NEW 4 RING STATOR	4
NEW LIP SEALS	8
NEW PARKING GUIDE BRACKET AND PARKING PAWL	10
NEW TRANSAXLE CONTROLLER AND LOCATIONS	12
NEW BELL HOUSING BOLT PATTERNS	15
NEW 4 DISC OVERDRIVE CLUTCH ASSEMBLY	20
NEW PRNODL AND NEUTRAL SAFETY SWITCHES	26
NEW GEAR RATIOS AND IDENTIFICATION	28
NEW (5TH DESIGN) TRANSAXLE CONTROLLER	32
NEW 1990 1/4 OVERDRIVE/REVERSE PISTON	33
NEW 1990 1/4 INPUT CLUTCH HUB	38
2/4 AND L/R CLUTCH PACKS (ASSEMBLY TIP)	42
PREMATURE FAILURE OF O.D. AND REVERSE CLUTCHES	45
FAULT CODES	46
FAULT CODE EXPLANATION	47
DIAGNOSTIC CONNECTOR LOCATION	72

AUTOMATIC TRANSMISSION SERVICE GROUP

Chrysler A604

Figure 7

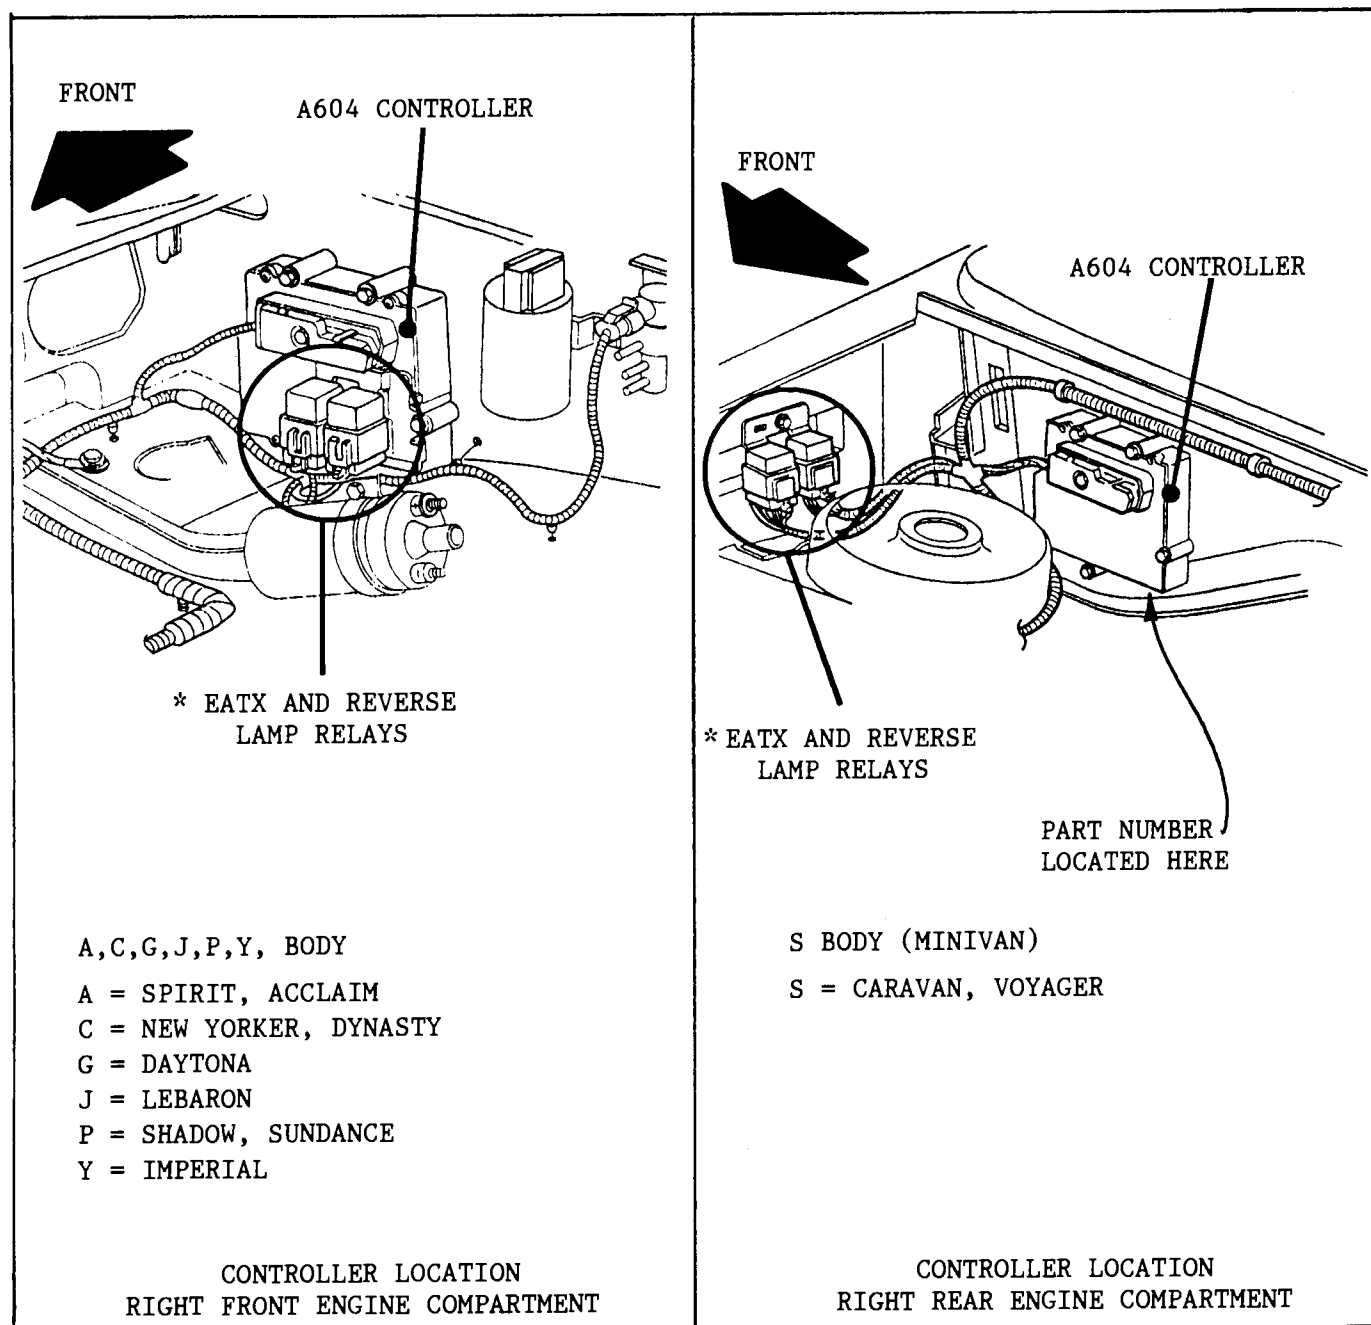
- (1) TRANSAXLE CONTROLLER - The controllers are identified by the last three digits of the OEM part number. The part number is on a sticker that is located on the bottom of the controller as shown in Figure 7. The locations of the controllers will vary depending on the model of the vehicle. Refer to Figure 7 for the different locations. Figure 7 and 8 also shows the locations of the EATX relay, as their location will also vary depending on the model of the vehicle.

- (1) TRANSAXLE CONTROLLER - The controllers are identified by the last three digits of the OEM part number. The part number is on a sticker that is located on the bottom of the controller (See Figure 7).
The locations of the controllers will vary depending on the model of the vehicle (See Figure 7)

The new #120 Transaxle Controller will retro-fit back to ALL previous model A604 transaxles equipped with the earlier part numbers 5234623, 5234649, or 5234678.

NOTE: When updating earlier controllers, do not Routinely replace the controller P/N 5234678 with P/N 4557120, Unless the customer has encountered highway cycling driveability conditions. When updating controller P/N 5234623 or P/N 5234649, by all means use controller P/N 4557120.

Figure 13

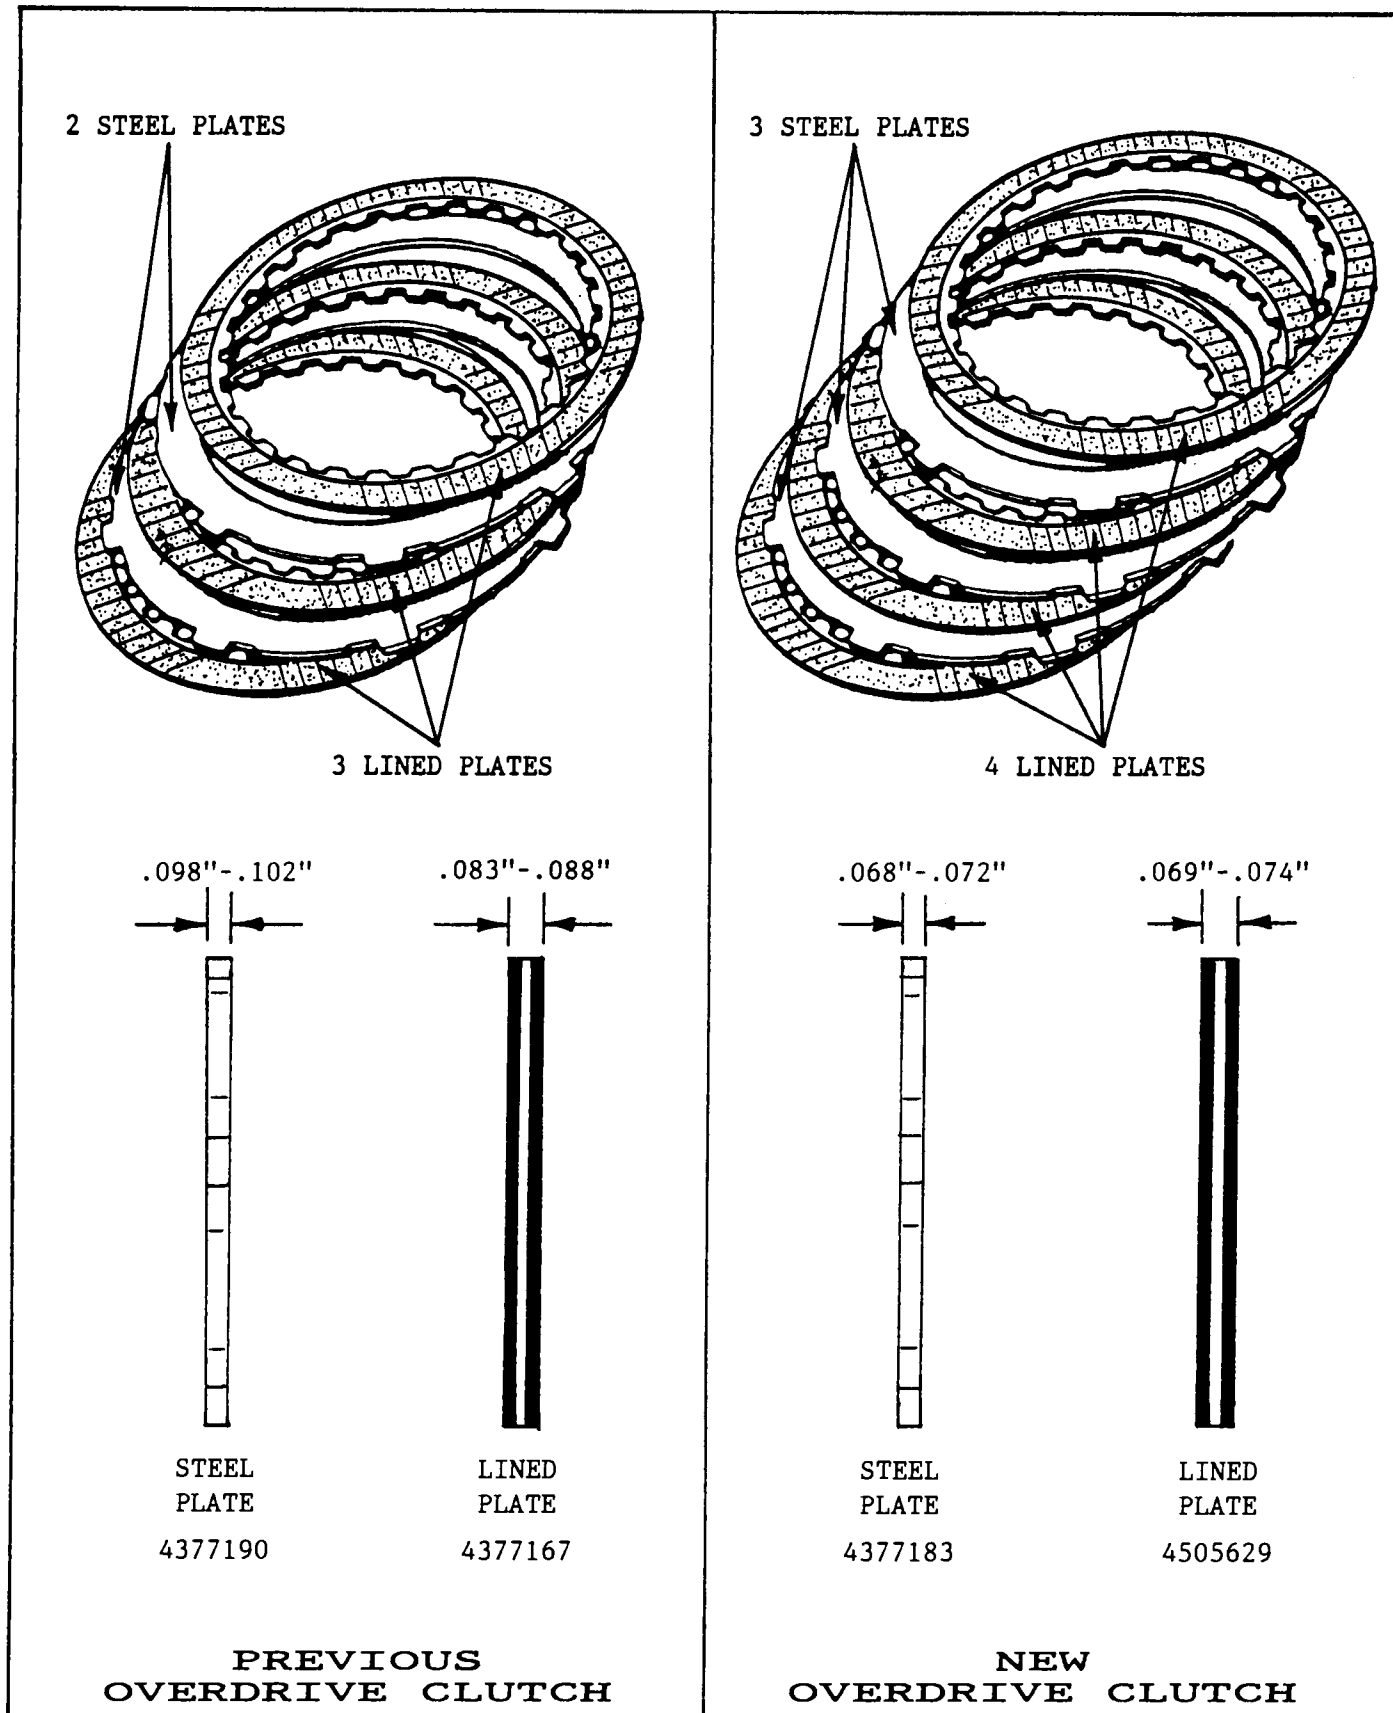
CHANGE: A running change for 1990 model A604 transaxles was the introduction of a four (4) disc Overdrive Clutch Assembly, to replace the previous three (3) disc assembly (See Figure 13).

- (1) OVERDRIVE LINED PLATES - Now uses 4 lined plates instead of the previous 3 lined plates, and the lined plates for 1990 models are .014" thinner than the 1989 lined plates (See Figure 13), to help accomodate the extra lined plate. The 1989 lined plates will measure .083"-.088" thick, and the new lined plates will measure .069"-.074" thick (See Figure 13).

- (2) OVERDRIVE STEEL PLATES - Now uses 3 steel plates instead of the previous 2 steel plates. The new steel plates are .030" thinner, and measure .068"-.072" thick. The previous steel plates measure .098"-.102" thick. (See Figure 13).

None of the parts listed above will interchange with one another between 1989 and 1990 model years. It is imperative that you "Positively" I.D. each part to insure that you are assembling with compatible parts.

Figure 14

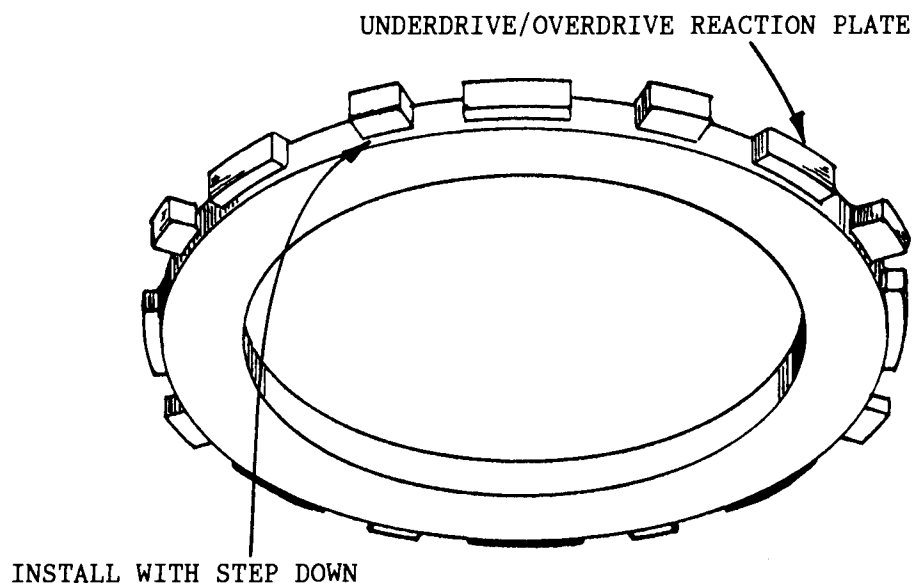
- (3) UNDERDRIVE/OVERDRIVE REACTION PLATES - The 1989 Underdrive/Overdrive Reaction Plates have always been available in 4 different thicknesses to obtain proper clutch clearance. For 1990, each plate was reduced in thickness by .040", to help accomodate the extra overdrive plates. (See Figure 14).

FOR 1990, EACH REACTION PLATE WAS REDUCED IN THICKNESS BY .040", TO ACCOMMODATE THE EXTRA OVERDRIVE PLATES.

Figure 15

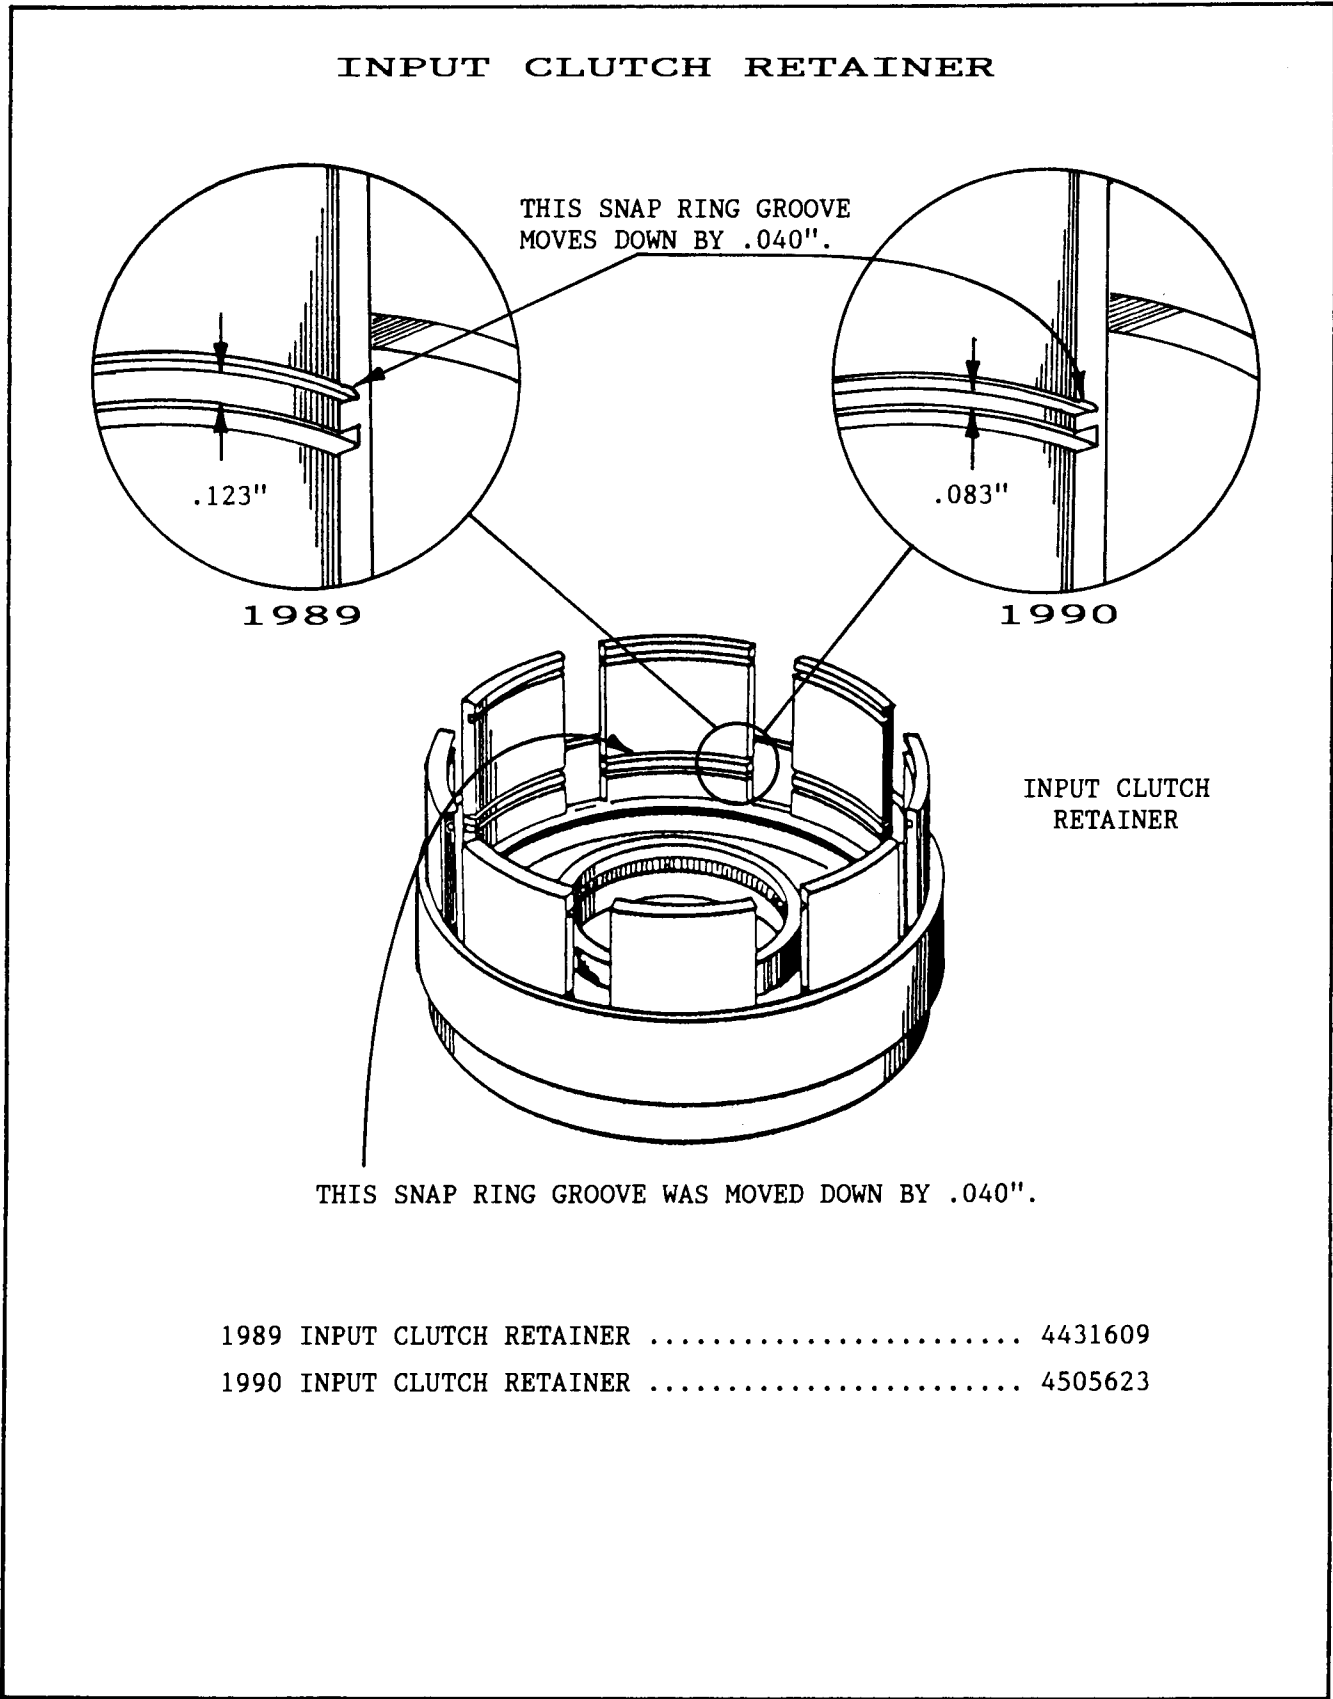
- (4) INPUT CLUTCH RETAINER - The underdrive/overdrive reaction plate tapered snap ring groove was moved "Down" by .040" (Can be Detected Visually) to accomodate the thinner underdrive/overdrive reaction plates (Figure 15). Another change that occurred at the same time is the underdrive clutch outer lip seal groove depth is .040" "Shallower" to accomodate a new underdrive clutch outer lip seal (See Figure 16).

Figure 16

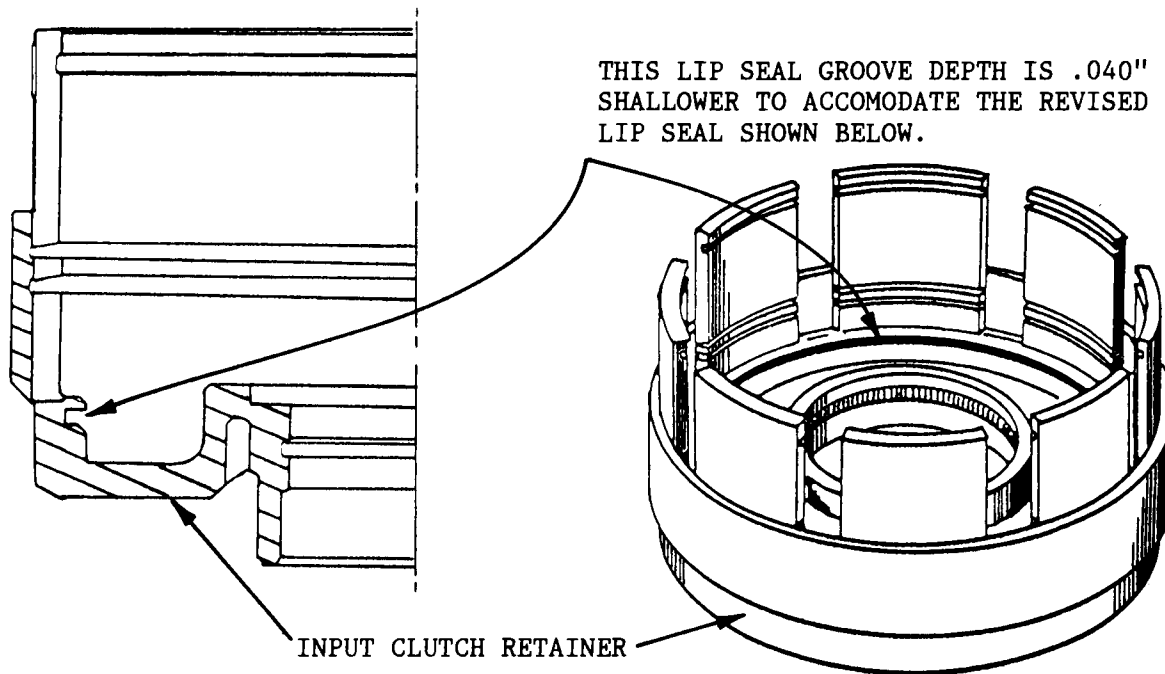
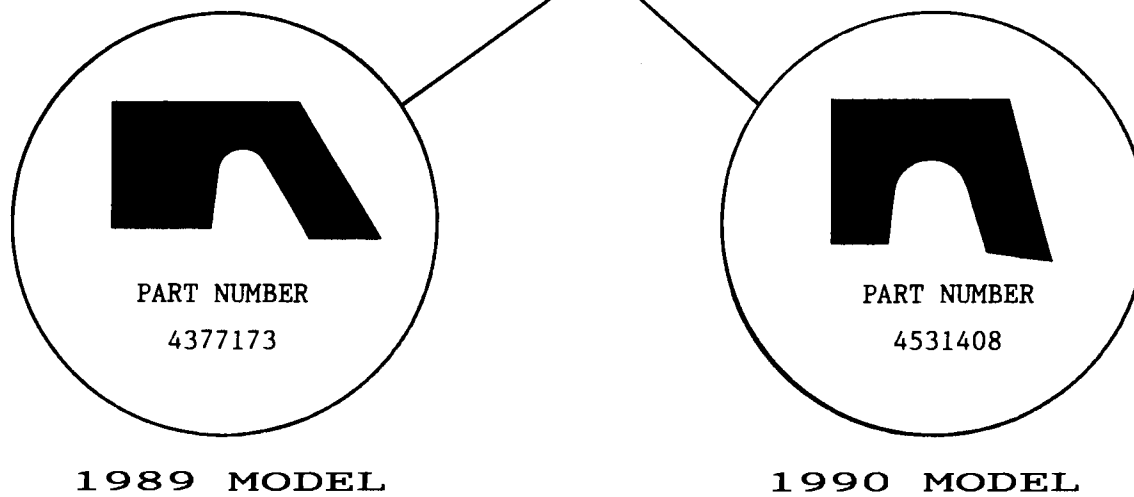
- (6) UNDERDRIVE CLUTCH OUTER LIP SEAL - The lip seal cross section has been reduced by .040" (Smaller in Overall Diameter) to accomodate the change in the depth of the groove in the input clutch retainer (See Figure 16). The OEM part number is printed on the seals for identification. The 1989 (Large) is 4377173, and the 1990 (Small) is 4531408. This will confirm that you have the proper seal for this location (See Figure 16).

FIGURE 18

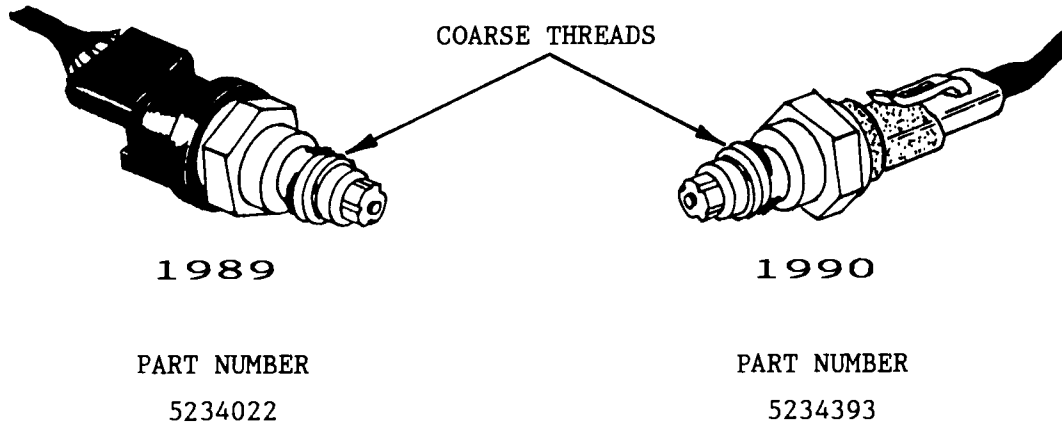
- (1) PRNODL SWITCH AND CONNECTOR - The PRNODL Switch and its wiring harness connector have changed for 1990, and can be identified visually (See Figure 18). These PRNODL Switches WILL NOT interchange with one another.
- (2) NEUTRAL SAFETY SWITCH AND CONNECTOR - The Neutral Safety Switch and its wiring harness connector have changed for 1990, and can be identified visually (See Figure 19). These Neutral Safety Switches WILL NOT interchange with one another.

THESE PRNODL SWITCHES WILL NOT INTERCHANGE.

The 1989 and 1990 Switches are not compatible with one another and WILL NOT interchange between these model years.

FIGURE 19

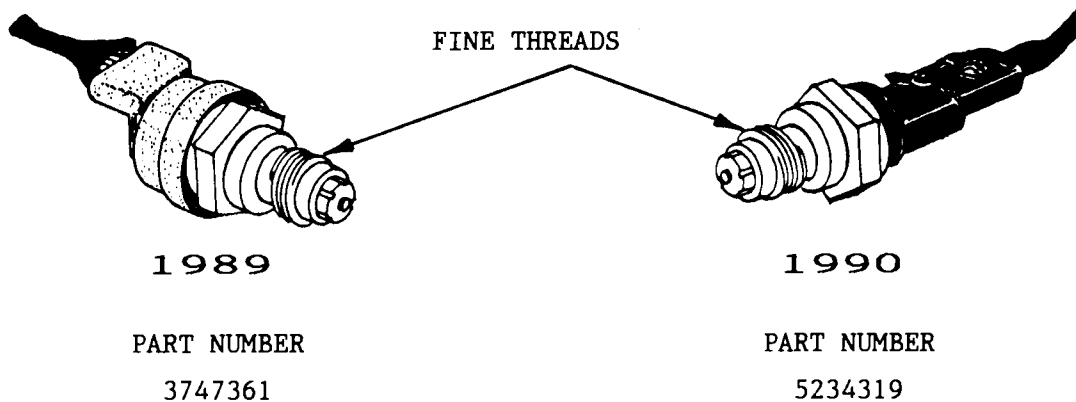
THESE NEUTRAL SWITCHES WILL NOT INTERCHANGE.
